ITEM #: 36  
DATE: 09-22-15

### COUNCIL ACTION FORM

**REQUEST: PRELIMINARY PLAT FOR HAYDEN'S CROSSING  
CONSERVATION SUBDIVISION**

**Attachment L: Proposed Trail Connection  
(As Shown on Preliminary Plat)**

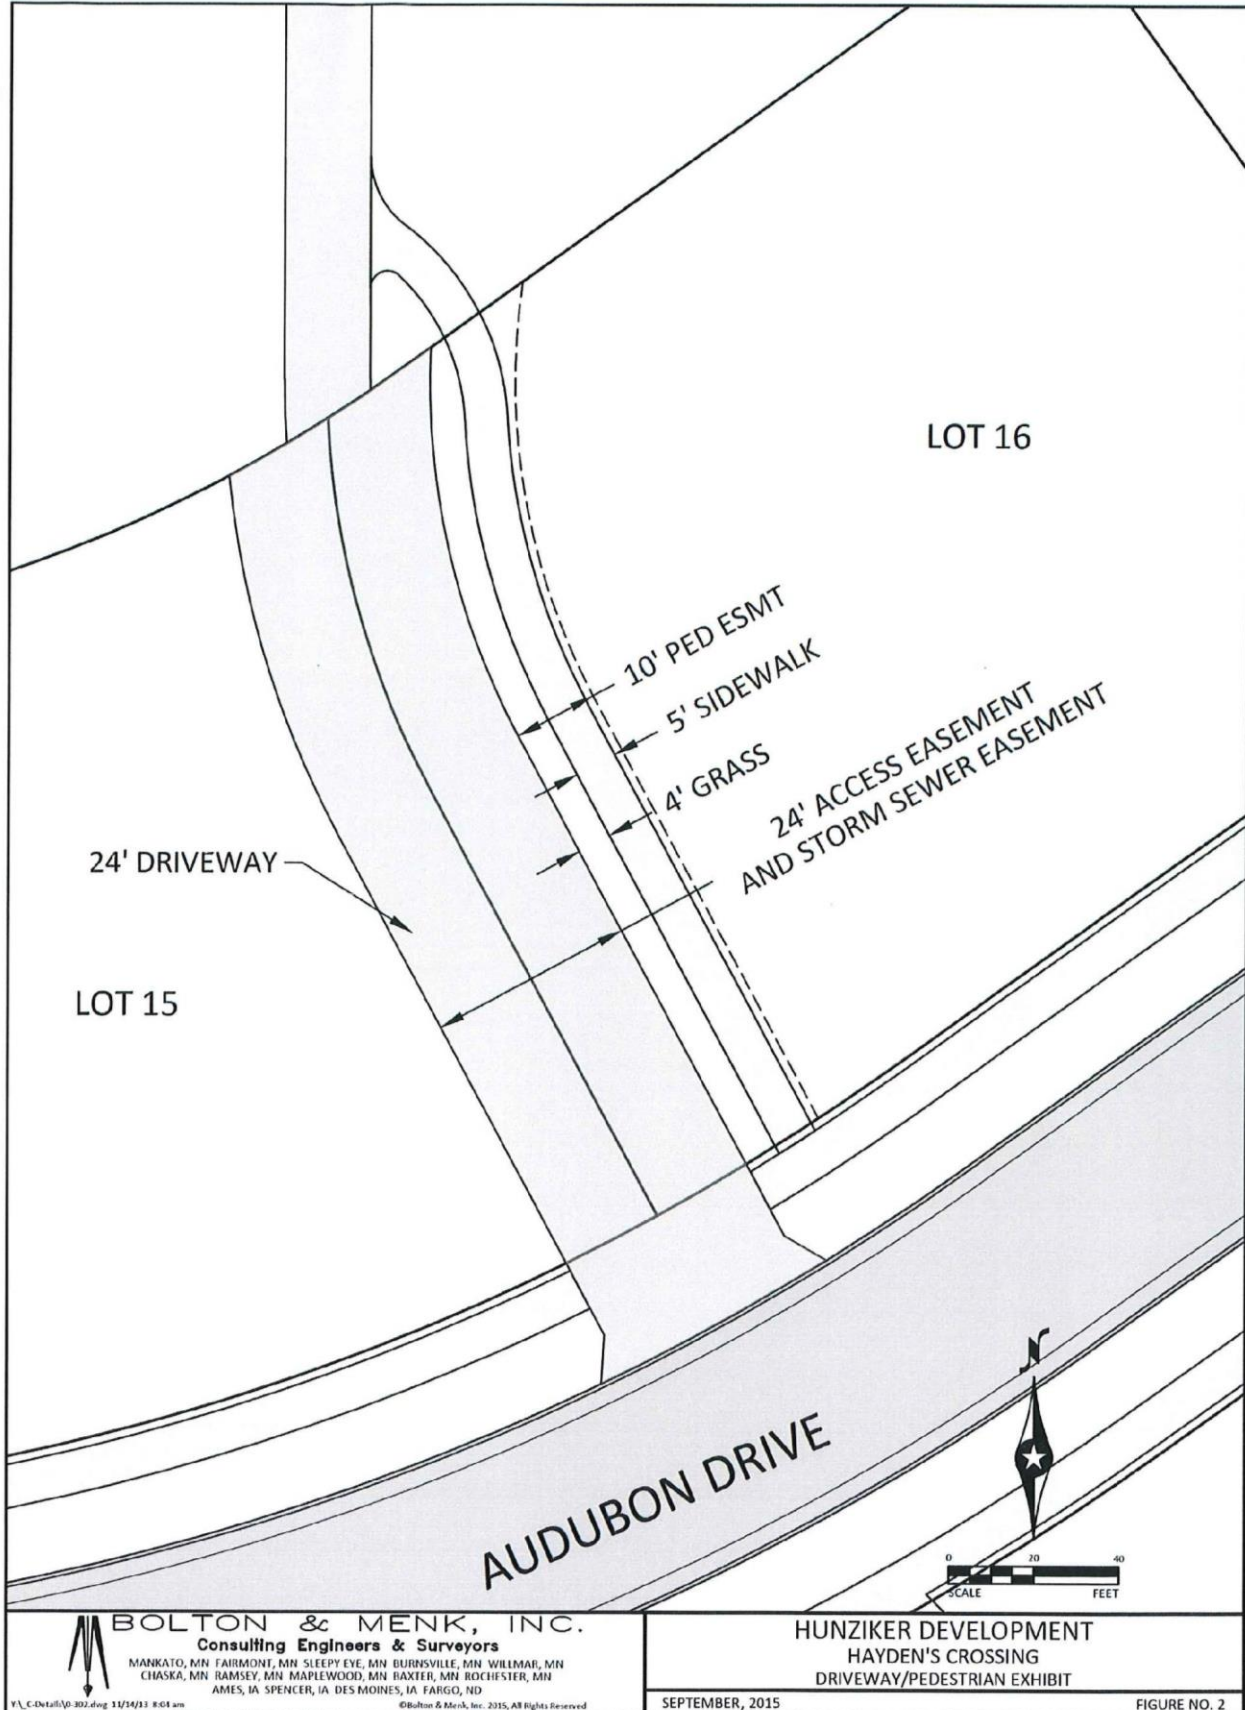
The Commission recommended approval of the Preliminary Plat with the separated sidewalk as shown in Attachment L by a vote of 5 to 1. This recommendation included

Where the trail crosses Lots 15 and 16, a separate concrete walkway is shown on the Preliminary Plat (5 feet wide) in a 10-foot wide pedestrian easement running along the east edge of the shared driveway for Lots 15 and 16. The pedestrian trail extends through the full width of Outlot B as a 10-foot wide concrete walkway, and ends at the boundary between Outlot B and Outlot ZZ. At the time Outlot ZZ is divided into additional residential lots, the easements, the walkway and driveway planned for Lots 15 and 16 will be repeated to cross the two new lots, and connect to a street serving those lots.

Staff has communicated our concerns to the Developer about combining the pedestrian walkway and the driveway into one surface with pavement markings. It is staff's belief that the pedestrian walkway needs to be separated from the driveway to clearly differentiate the path from the driveway as a means to clearly denote the route that pedestrians and bikers are to follow, as well and to avoid a potential conflict between people parking on the shared driveway and pedestrian/bikers passing through the easement. The Developer's proposal use a solid 4-inch white line to demark the pedestrian path from the driveway appears to be a more temporary solution, without a plan and commitment for ongoing maintenance of the painted line.

**Attachment M: Driveway/Trail Design  
(As Proposed by Developer)**

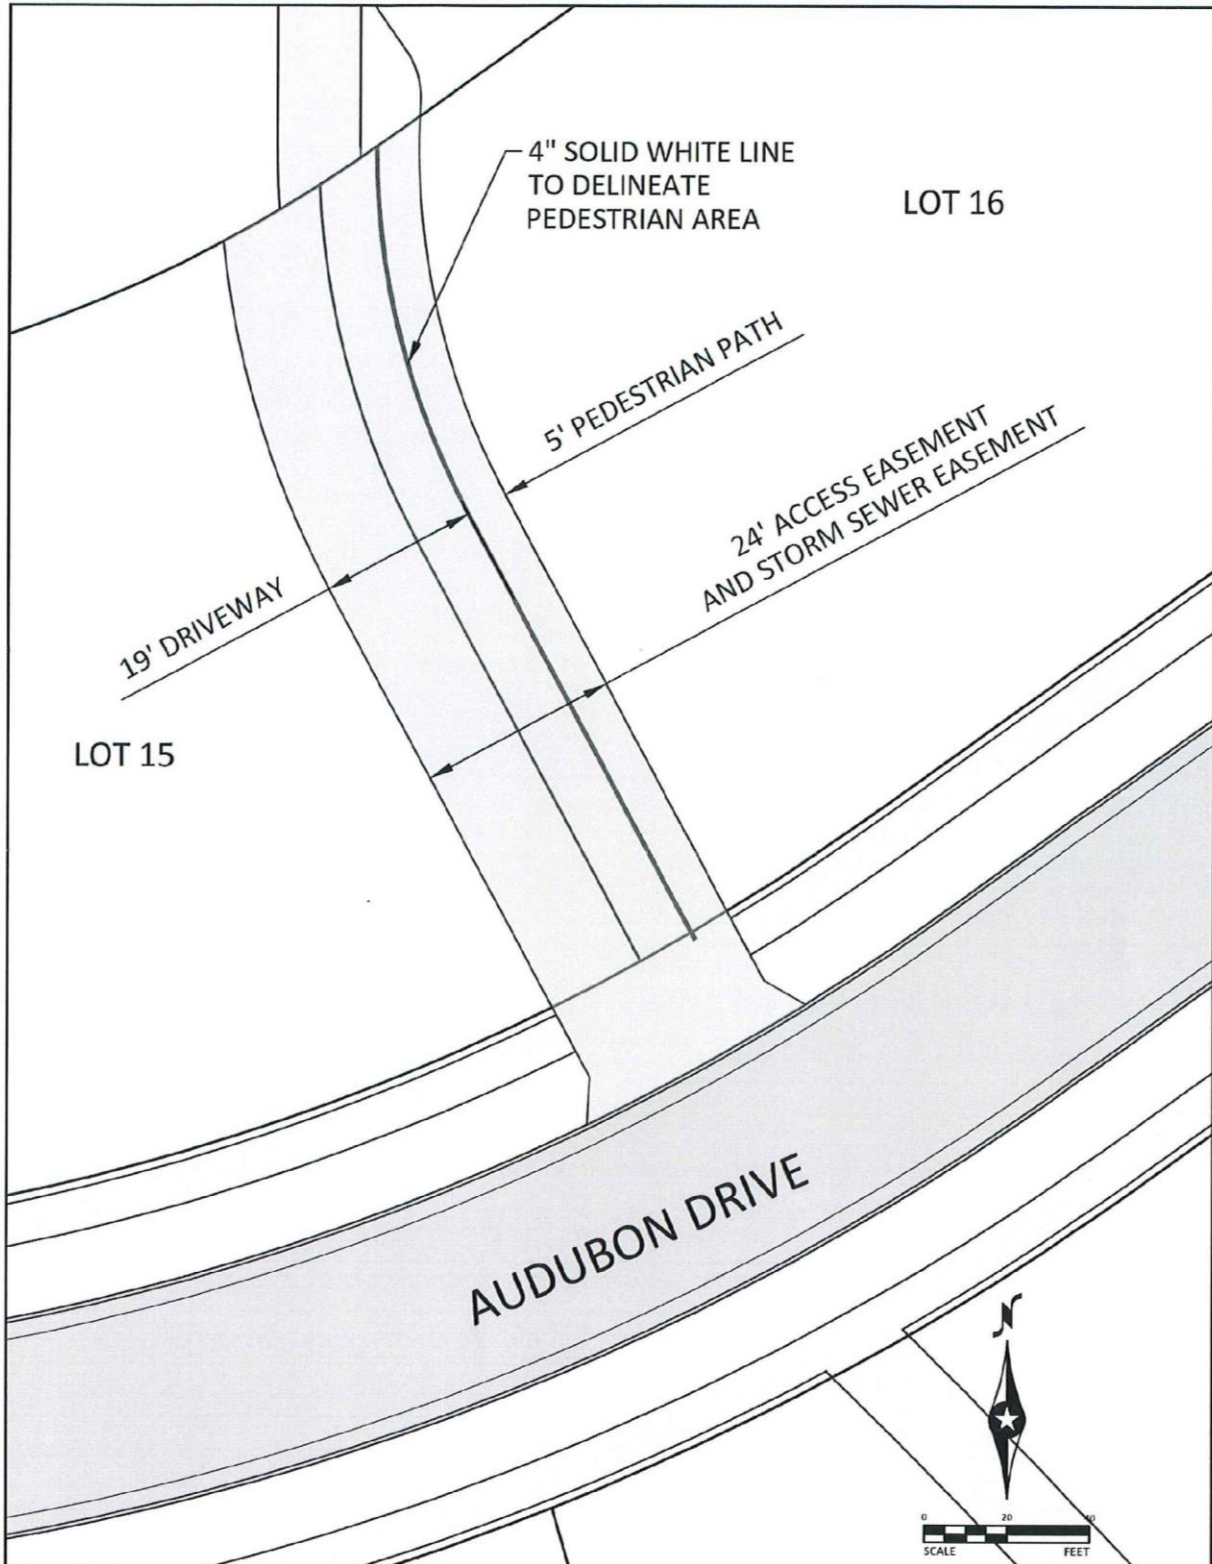
- How would the homeowners know that their driveways are a public share use path?
- How would those using the pedestrian trail know they are welcome to use the driveway, as part of the trail, between the houses on Lots 15 and 16?
- How would the public path be demarcated on the driveway to make it clear that the public has the right, and is invited, to walk through the space?
- It seems dangerous, and awkward, for pedestrians, bikers and vehicles to all use the shared driveway.
- A separate, distinct sidewalk would be a better long-term option than a single strip of pavement with markings.

There was much discussion at the Planning and Zoning Commission meeting, on September 2, 2015, concerning the design for vehicular access to Lots 15 and 16, in combination with pedestrian access through Lot 16, as a continuation of the trail that crosses through Outlots A and B. Justin Dodge, representing the Developer for the project, noted that the 5-foot wide pedestrian walkway, located in a 10-foot easement on Lot 16, is not necessary (*See Attachment L – Proposed Trail Connection, As Shown on the Preliminary Plat*). Mr. Dodge stated that the Developer believes the shared driveway for Lots 15 and 16, can easily function as a continuation of the pedestrian trail. He asserted that pedestrians could use the driveway as their connection with the trail that passes through Outlot B, since the volume of vehicular traffic using the driveway will be very low, and will not pose a conflict for pedestrians using the driveway as a trail. The Developer asserts that pavement markings could be added to delineate the pedestrian trail along the east edge of the shared driveway (*See Attachment M – Driveway/Trail Design, As Proposed by the Developer*).

We propose that you approve the Driveway Layout Figure 1 as attached. This will certainly be the path that a pedestrian would use rather than what is shown in Figure 2. While staff is recommending Figure 2, we believe that even if constructed, pedestrians would still use the paved easement as we propose in Figure 1 without the markings for a path as it aligns with the path connecting to Ada Hayden Park. While this is a conservation subdivision, we would like to minimize the additional impervious surfaces.
